PROPOSED MIXED-USE DEVELOPMENT, WHALLEY TRANSPORT ASSESSMENT ADDENDUM NOTE REV A

VN91274 – TA Addendum Note Rev A

4. Comments (dated 7th January 2020) on the TA were provided by Lancashire County Council (LCC) Highways Development Control Officer, Neil Stevens, and these are provided at **Appendix A** to this Note. Subsequently, Vectos met with Neil Stevens on the 19th February 2020 at the RVBC offices in Clitheroe to discuss the comments, and further dialogue has taken place over the course of 2020, with further information provided to LCC Highways through a TA Addendum Note in July, to which comments were provided by LCC Highways in October 2020. This revised TA Addendum Note therefore responds to all the comments received from LCC Highways to date.

Figure 1. PRoW and Informal Route at the Roundabout

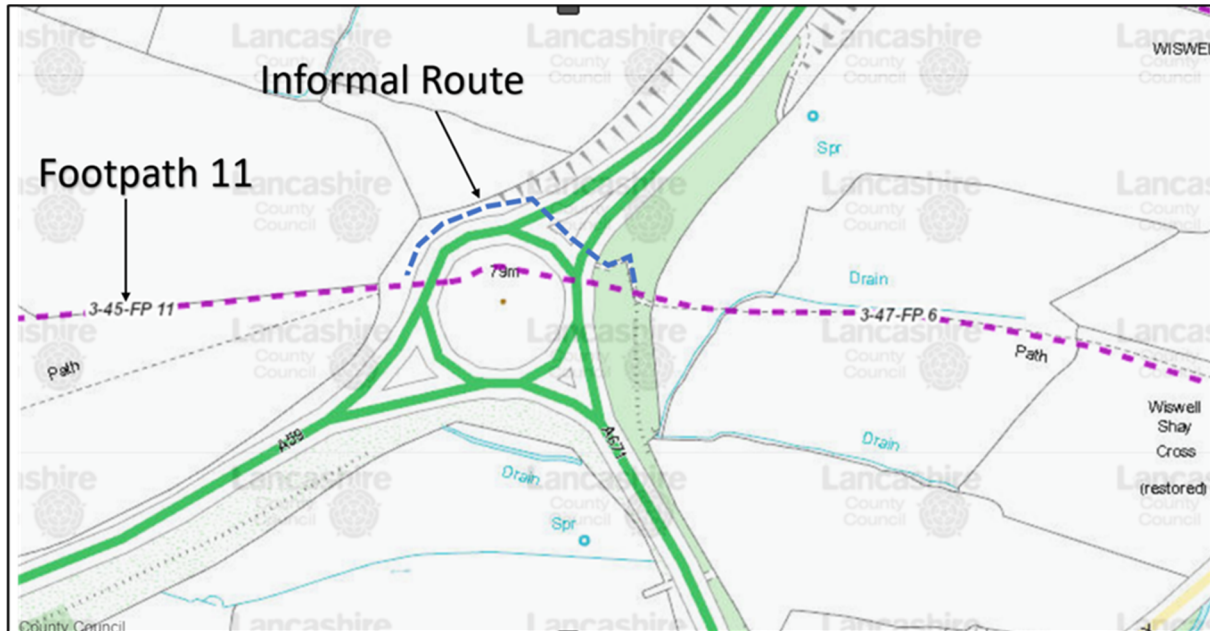
Whilst a footway is being promoted at the roundabout access, as presented does not provide any benefit, as a suggestion it could be extended to include existing footways linking into FP6/11 circa a further 50m to the east and I would also suggest provision to be provided extending a further 20m to the west.

13. The purple dashed line in **Figure 1** shows the existing PRoW alignment, whilst the blue dashed line has been added to show the informal route that appears to be used on the ground to negotiate this part of the network and which appears to have been formally surfaced in parts. The proposed access arm will provide footway on the northern side that will tie into this informal route, and a dropped kerb crossing with tactile paving will be provided across the access arm to facilitate pedestrian movements to link the southern side where the connection will be provided to Footpath 11, which will be diverted within the site.

14. The proposed development is not expected to result in a significant increase in pedestrian movements using the PRoW to and from the east, and this route is only used infrequently by leisure walkers. Notwithstanding, it is proposed to upgrade the section of informal path between the site boundary and the A59, and the short section in the verge on the opposite side of the A59, to provide a 2m path of paved material (bitmac or bound gravel/rural finish) and edged to retain structural integrity.

DRAWING TITLE:
Proposed 4th Arm off A59/A671 Roundabout

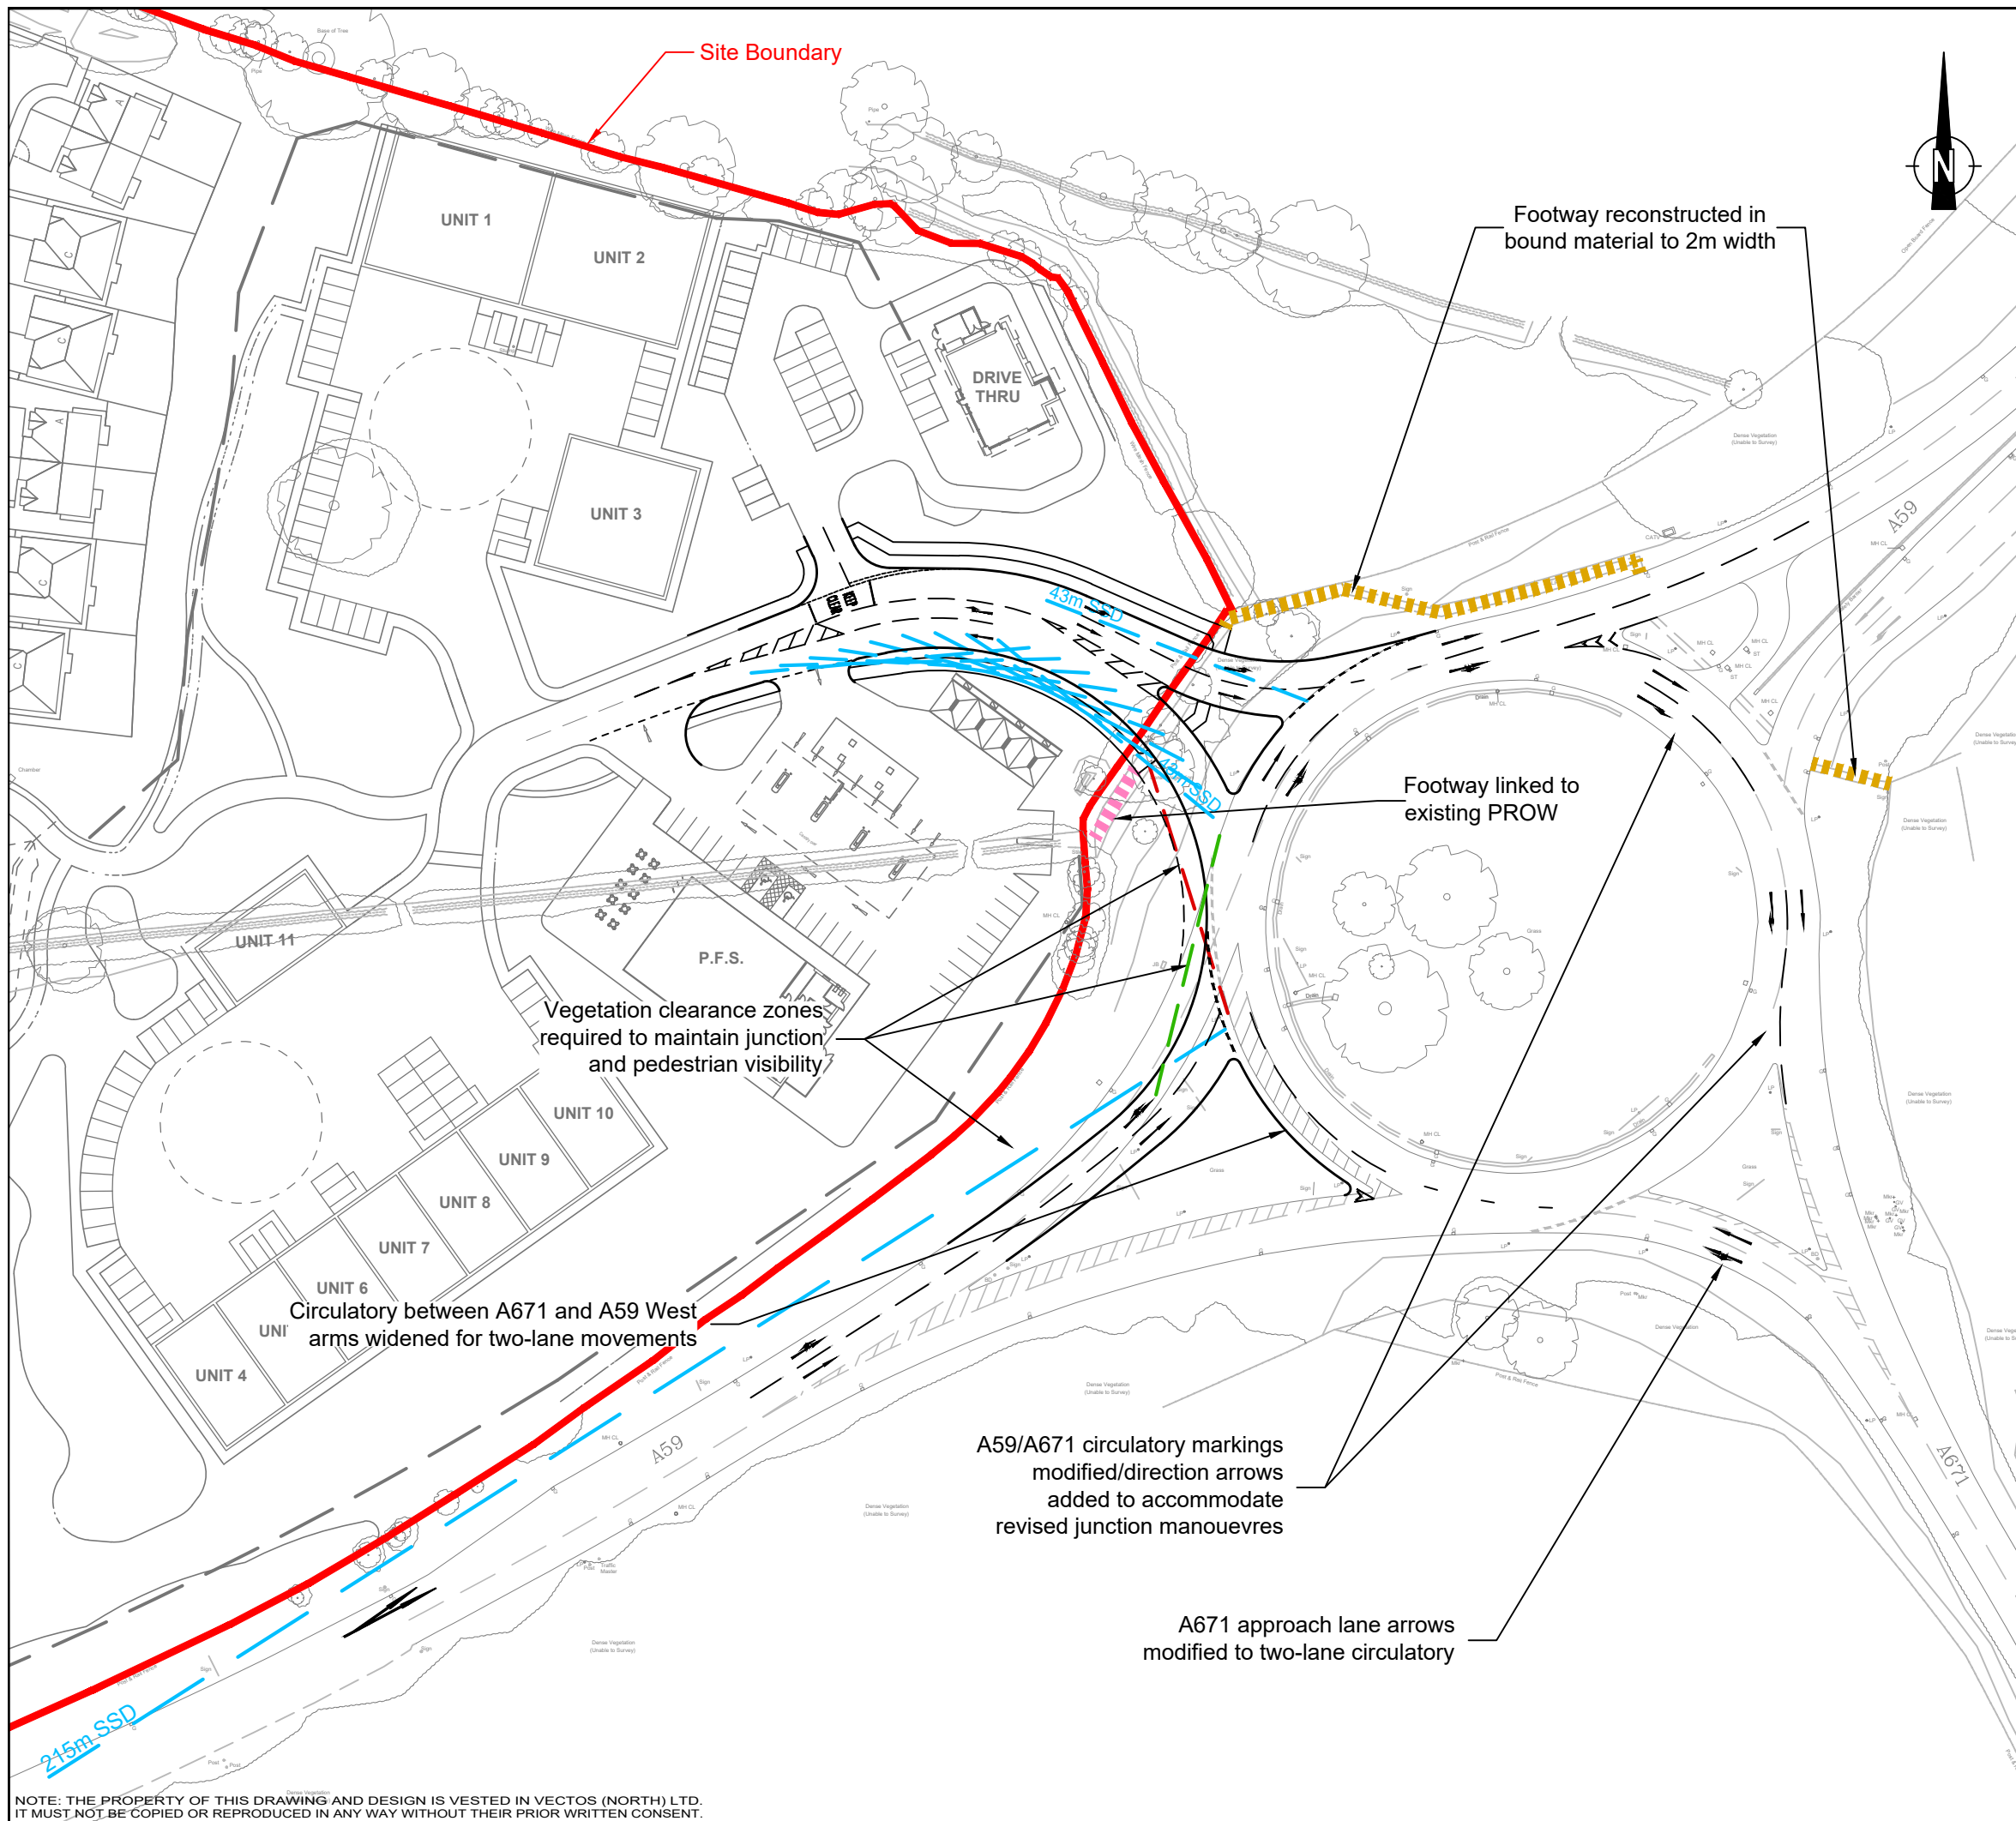
8. The proposed fourth arm access to the commercial land uses within the site has been amended following dialogue with LCC Highways and a stage 1 Road Safety Audit (RSA), the findings of which are presented in the report at **Appendix C** to this Note. Vectos have responded to the RSA as detailed in the RSA Response Report at **Appendix D** to this Note. The updated design, taking account of the RSA comments and the LCC Highways comments is shown in **Vectos Drawing VN40390-SK001 H**. The key changes to the design compared to that submitted as part of the original TA are as follows:

- An amendment to the alignment of the A59 northbound approach arm to help reduce speeds on approach and widening of the approach lanes.
 - An increase in the radius of the site access arm to assist a smooth exit from the roundabout.

- Widening of the proposed site access arm to better accommodate HGV movements.
 - Widening of the south-west circulatory to provide two circulatory lanes.

- Amended road marking on A671 approach nearside lane to ahead and right arrow.
 - Provision of dropped kerbs and tactile paving to assist pedestrian crossing of the site access arm.

H	West circulatory widened to 2 lanes	dlb	TR	18.11.20
G	Various changes to LCC 10/20 comments	dlb	TR	9.11.20
F	RSA1 changes, items 5.1 & 5.2	dlb	TR	22.07.20
E	Site access entry lane widened	dlb	TR	19.06.20
D	Various amendments to review comments	dlb	TR	27.05.20
C	A59 entry and Dev access realigned	dlb	RW	24.02.20
B	Amended to suit new master plan layout	JD	RW	6.06.19
A	Lane removed from exit carriageway	JD	RW	6.12.17

DRAWING TITLE:
**Proposed 4th Arm off
A59/A671 Roundabout
Whole Junction Geometric Check**

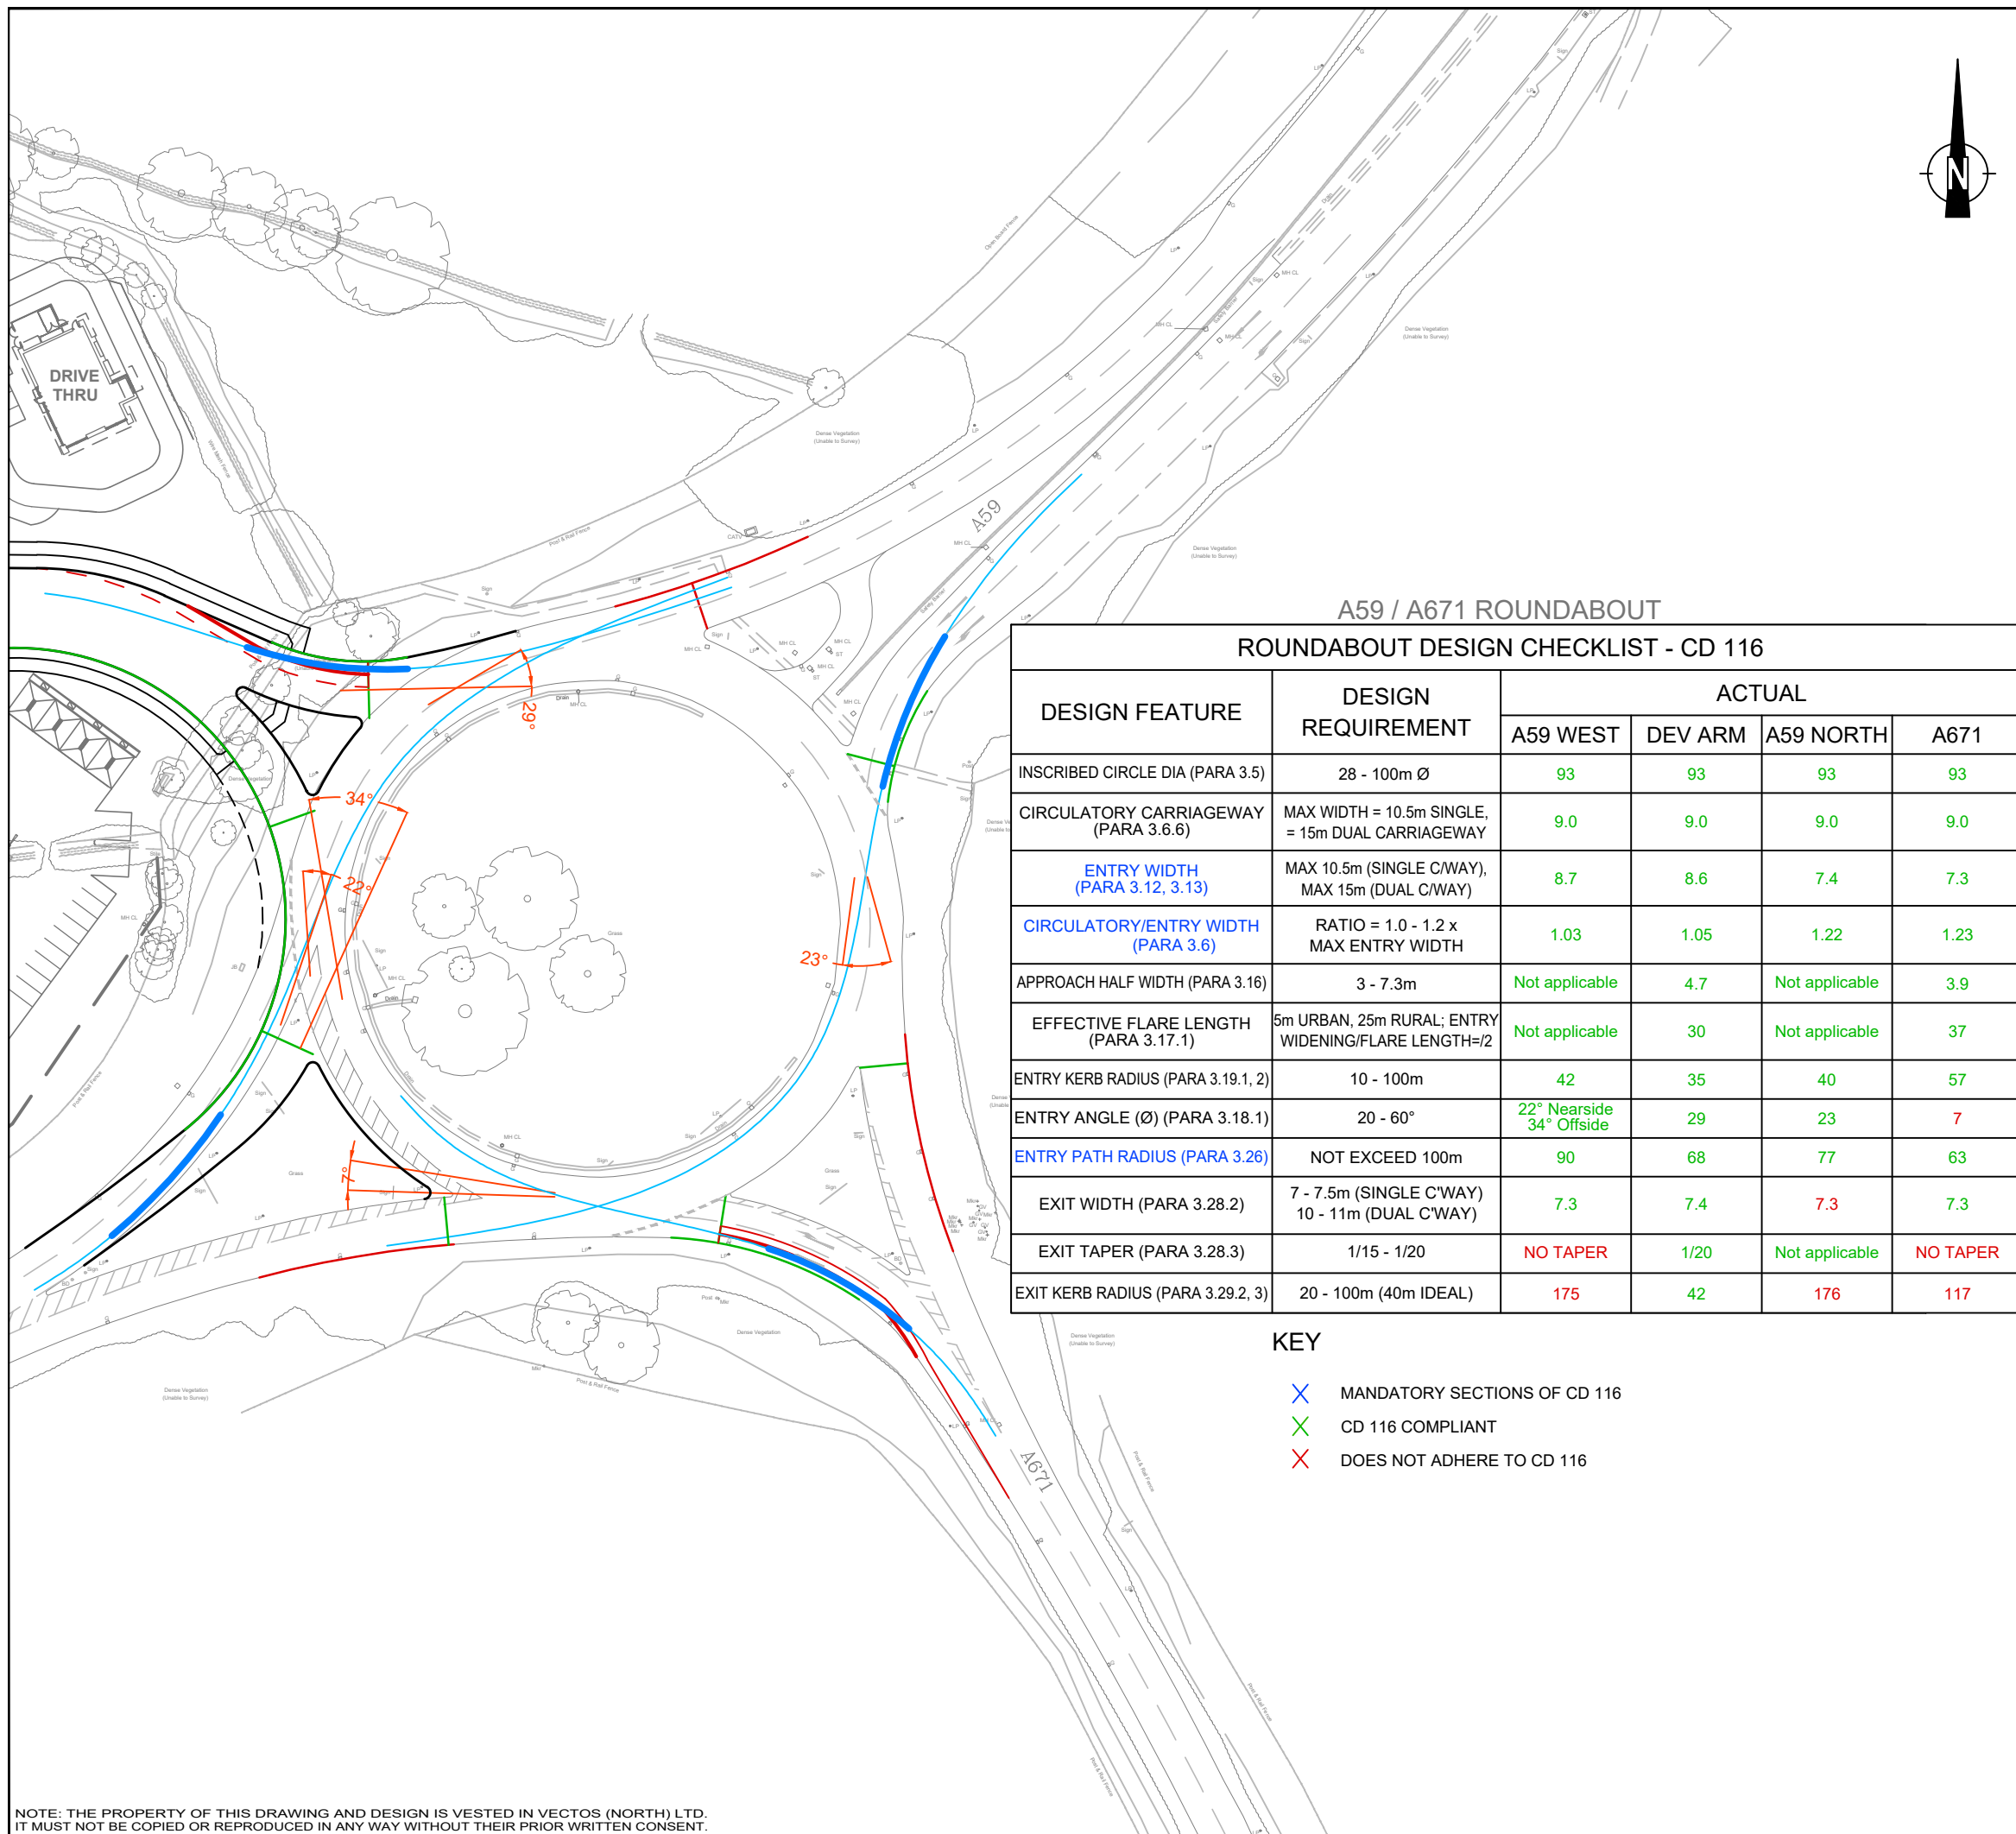
9. The roundabout design checklist is shown in **Vectos Drawing VN40390-SK001/GEO H**. This shows that the roundabout as proposed is compliant with all mandatory standards as defined in the Design Manual for Roads and Bridges (DMRB) document CD116 'Geometric Design of Roundabouts'.
